APPLICATION NO.	FILING DATE	FIRST NAMED INVENTOR	ATTORNEY DOCKET NO.	CONFIRMATION NO.
10/675,539	09/30/2003	Mark Maney	03RE076/YOD REEL:0046	5965

Office Action Summary	Application No.	Applicant(s)	
	10/675,539	MANEY ET AL.	
	Examiner	Art Unit	
	Tamai I.E. Karl	2834

1. The amended title, "VENTILATED STATOR CORE AND LAMINATION AND METHOD OF COOLING SAME", of the invention is not descriptive. A new title is required that is clearly indicative of the invention to which the claims are directed. The examiner suggests "VENTILATED STATOR CORE AND LAMINATIONS HAVING CANTILEVERED FINS IN COOLING DUCTS".

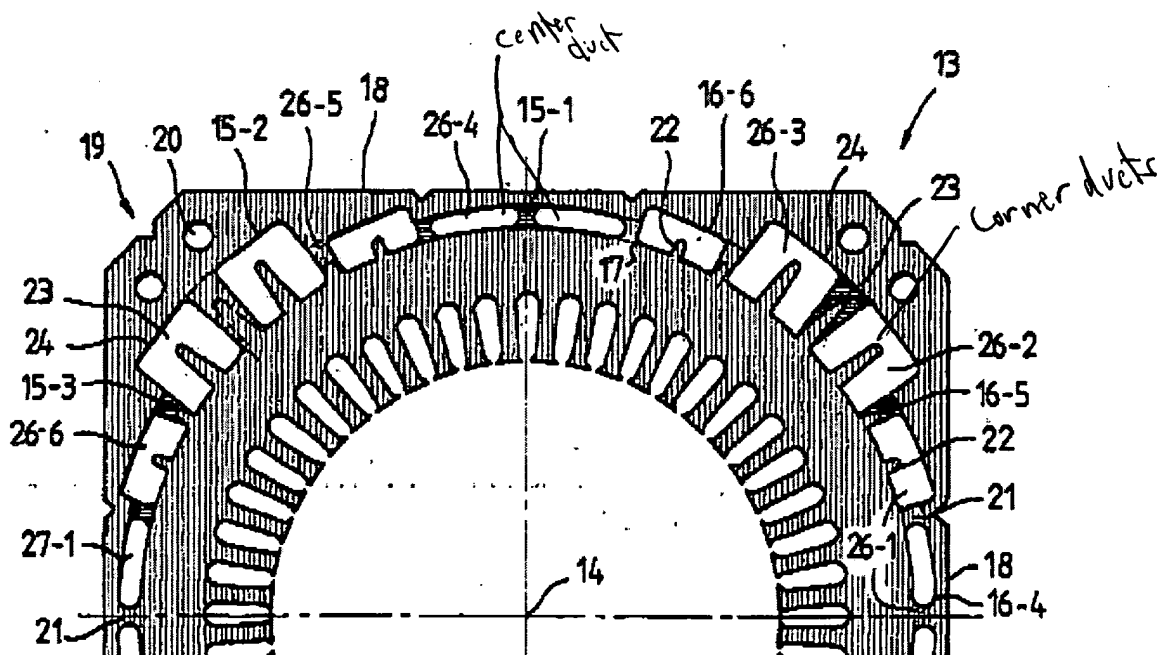
8. Claims 7, 10-12, and 34 are rejected under 35 U.S.C. 102(b) as being clearly anticipated by Gutjahr et al. (Gutjahr)(DE 199 17 409). Gutjahr teaches a laminated stator with a central aperture for the rotor and a plurality of slots. The outer periphery defining a square with chamfered corners. The lamination having a plurality of corner ducts 23 in each of the corners with a cantilevered fins 22 and a plurality of center ducts 27 centered (having a major axis) around the vertical and horizontal axis to cool the laminations. It is inherent that the corner and center ducts are configured to force air into the center ducts. Gutjahr shows the fins equally spaced to balance the airflow and cool the lamination. Gutjahr shows channels 4 in the rotor 4 for cooling air flow 28.

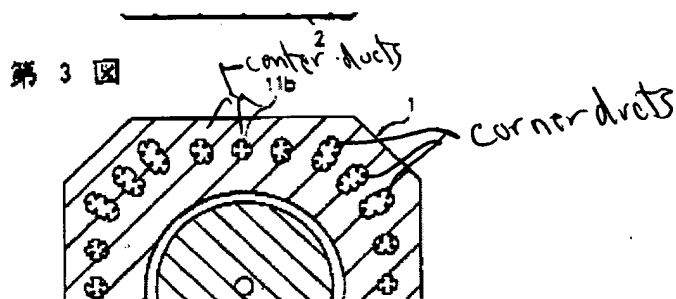
9. Claims 7, 10-12, and 34 are rejected under 35 U.S.C. 102(b) as being clearly anticipated by Koyama et al. (Koyama)(JP 57-129,139). Koyama teaches a laminated stator with a central aperture for the rotor and a plurality of slots for the winding 3. The winding extending from the side of the core such that they are inherently in slots. The

outer periphery defining a square with chamfered corners. The lamination having a plurality of mirrored corner ducts in each of the corners with a cantilevered fins/projections and a plurality of mirrored center ducts to cool the laminations. The center ducts are centered (having a major axis) around the vertical and horizontal axis to cool the laminations. It is inherent that the corner and center ducts are configured to force air into the center ducts. The drawings show the cooling projections equally spaced around the passages 11b to balance the air flow in the ducts.

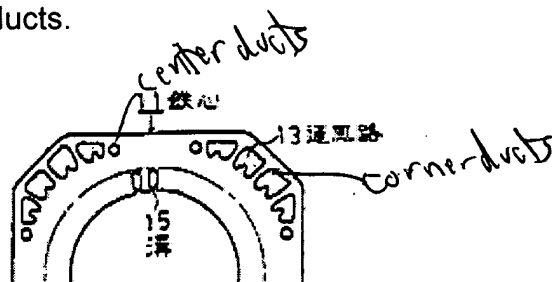
10. Claims 7, 10-12, and 34 are rejected under 35 U.S.C. 102(b) as being clearly anticipated by Furukawa et al. (Furukawa)(JP 03-049542). Furukawa teaches a laminated stator core 11 with a central aperture for the rotor and a plurality of slots 15 for the winding. The outer periphery defining a square with chamfered corners. The laminations (figure 1) having a plurality of mirrored corner ducts in each of the corners with a cantilevered fins/projections and a plurality of mirrored center ducts to cool the laminations. The examiner notes that the drawings do not label the circular openings adjacent the air passages 13, but the drawings can be used for what they reasonably convey to a person of ordinary skill in the art (*In re Aslanian*, 590 f.2d 911, 200 UPSQ 500 CCPA (1979)). The center ducts are centered (having a major axis) around the vertical and horizontal axis to cool the laminations. It is inherent that the corner and

center ducts are configured to force air into the center ducts. The drawings show the cooling projections equally spaced around the passages 11b to balance the air flow in the ducts.

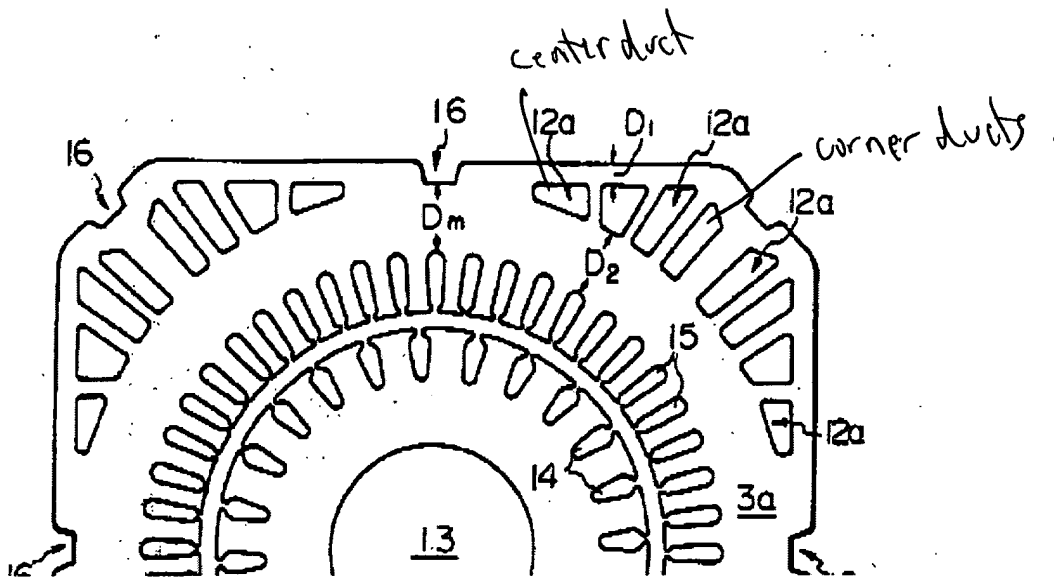
11. Claims 7, 10, and 12 are rejected under 35 U.S.C. 102(b) as being clearly anticipated by Harano et al. (Harano)(US 4406959). Harano teaches a laminated stator core 3 with a central aperture for the rotor and a plurality of slots 15 for the winding. The outer periphery defining a square with chamfered corners. The laminations (figure 2) having a plurality of mirrored corner ducts in each of the corners with a cooling fins and a plurality of mirrored center ducts to cool the laminations. The center ducts are centered (having a major axis) around the vertical and horizontal axis to cool the laminations. It is inherent that the corner and center ducts are configured to force air into the center ducts.
